## **Access Compliance Report Public Rights-of-Way** (Curb Ramps)

Intersection ID: 10034400 Main Street: PIEDMONT PARK DR Cross Street: SAGE\_PARK\_DR Location: S ADA ID: 14E9780EB551 Ramp Type: Directional1 Initial Pass/Fail: Fail **Overall Compliance: No Severity Score:** 12.5

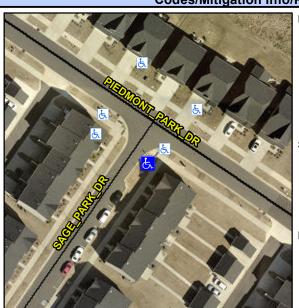
ried Measurements/Component Componence					
Compliance Description		Data	Compliance Description		Data
N/A	Ramp Length (in)	54.0	N/A	Grade Break?	N/A
Yes	Ramp Width (in)	71.0	N/A	Grade Break Slope (%)	0.0
No	Ramp Slope (%)	8.4	N/A	Grade Break XSlope (%)	0.0
Yes	Ramp XSlope (%)	0.9			
N/A	Flare Type LT	N/A	N/A	Flare Type RT	N/A
N/A	Flare Slope LT (%)	N/A	N/A	Flare Slope RT (%)	0.0
N/A	Flare Traversable LT?	N/A	N/A	Flare Traversable RT?	N/A
N/A	Landing Length (in)	0.0	N/A	DWS Provided?	N/A
N/A	Landing Width (in)	0.0	N/A	DWS Contrast?	N/A
N/A	Landing Slope (%)	0.0	N/A	DWS Length (in)	N/A
N/A	Landing X Slope (%)	0.0	N/A	DWS Full Width?	N/A
N/A	Landing Curb? (Y/N)	N/A	N/A	DWS Offset LT (in)	N/A
N/A	Shared Landing?	N/A	N/A	DWS Offset RT (in)	N/A
N/A	Gutter Ponding?	0.0	N/A	Gutter Slope (%)	N/A
N/A	Gutter Lip Ht (in)	0.0	N/A	Gutter X Slope (%)	N/A
N/A	Painted X Walk1?	No		Road Slope (%)	0.9
	X Walk 1 Direction	To NE		Road X Slope (%)	2.6

Possible Solutions: Remove & Replace Entire Ramp. Surveyor Notes: N/A PROW/ADA: R304.2.2
